ARCHITECTURAL REVIEW BOARD STAFF REPORT

Project #/Name	ARB-2024-71: 400 Rio Rd. West Outdoor Storage, Display, and Sales
Review Type	Conceptual Plan
Parcel Identification	04500-00-00-025C0, 04500-00-00-025C1
Location	400 Rio Road West
Zoned	Light Industrial (LI) / Entrance Corridor (EC) / Airport Impact Area (AIA)
Owner/Applicant	Virginia Telephone & Telegraph Co / Williams Mullen (Valerie Long)
Magisterial District	Rio
Context	Most of 45-25C is paved. Additional paving is adjacent on 45-25C1. Chain link fence encloses much of the paved area. The property contains two structures, a brick-faced office building at the front of the site along Rio Rd. and a large metal shed towards the rear of the paved area. The rear portion of 45-25C1 is wooded. To the south across Rio Rd. and separated from it by a solid wood screening fence is the Four Seasons residential development. Additional single-family detached homes are to the east. To the west is a light industrial parcel housing an HVAC company. (See Fig. 1.)

Figure 1: Pictometry image showing the project area along the Entrance Corridor.

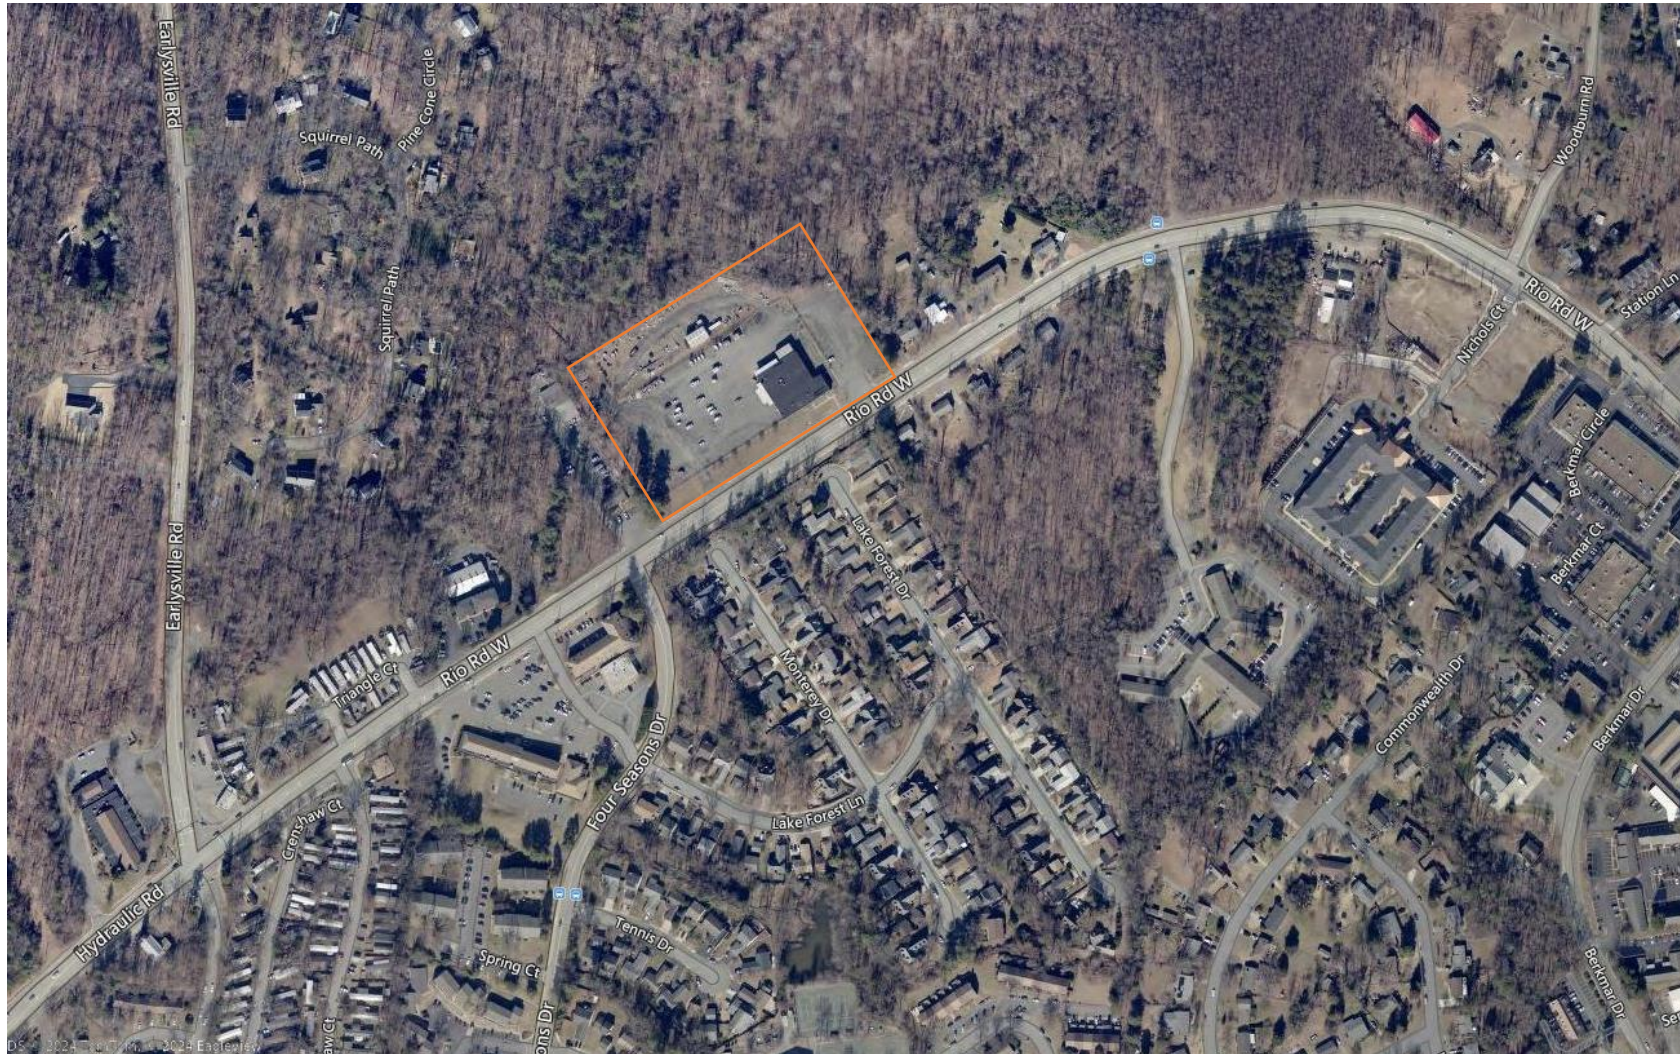
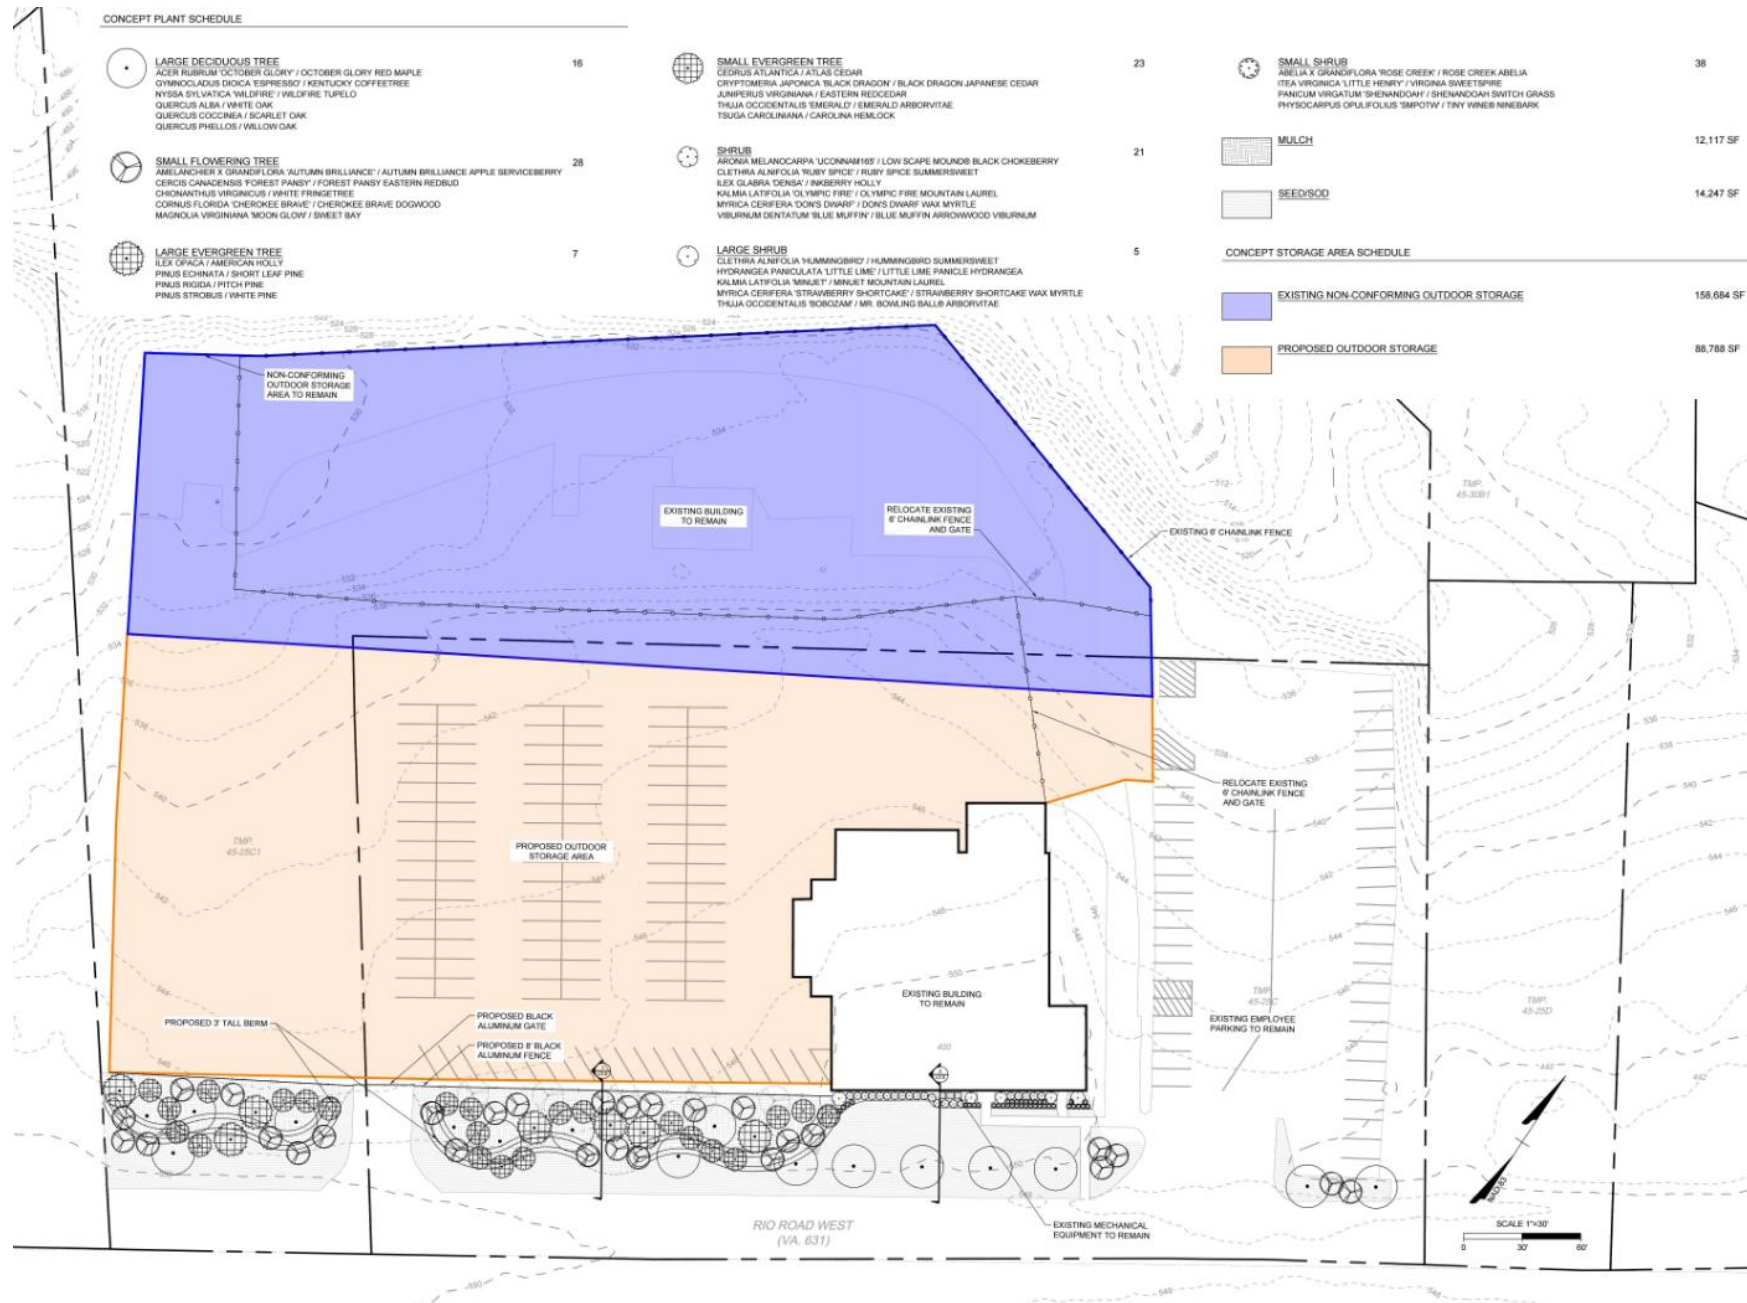
REF	GUIDELINE	ISSUE	RECOMMENDATION
	Purpose, Compatibility with the Character of the Entrance Corridor		
1	The goal of the regulation of the design of development within the designated Entrance Corridors is to ensure that new development within the corridors reflects the traditional architecture of the area. Therefore, it is the purpose of ARB review and of these Guidelines, that proposed development within the designated Entrance Corridors reflect elements of design characteristic of the significant historical landmarks, buildings, and structures of the Charlottesville and Albemarle area, and to promote orderly and attractive development within these corridors. Applicants should note that replication of historic structures is neither required nor desired.	This portion of the Rio Rd. EC is characterized by small- and large-scale (Cville Rio Rd. Apartments) residential developments with large trees near the frontage and wooded areas behind the developments on the north side of the street. The frontage of the subject parcel currently features a broad grass strip with little landscaping and unobstructed views of paving beyond. The proposed landscaping will help to fill in this area, visually connecting the parcel with the surrounding context and increasing the continuity along the EC.	See lighting and landscaping recommendations, below.
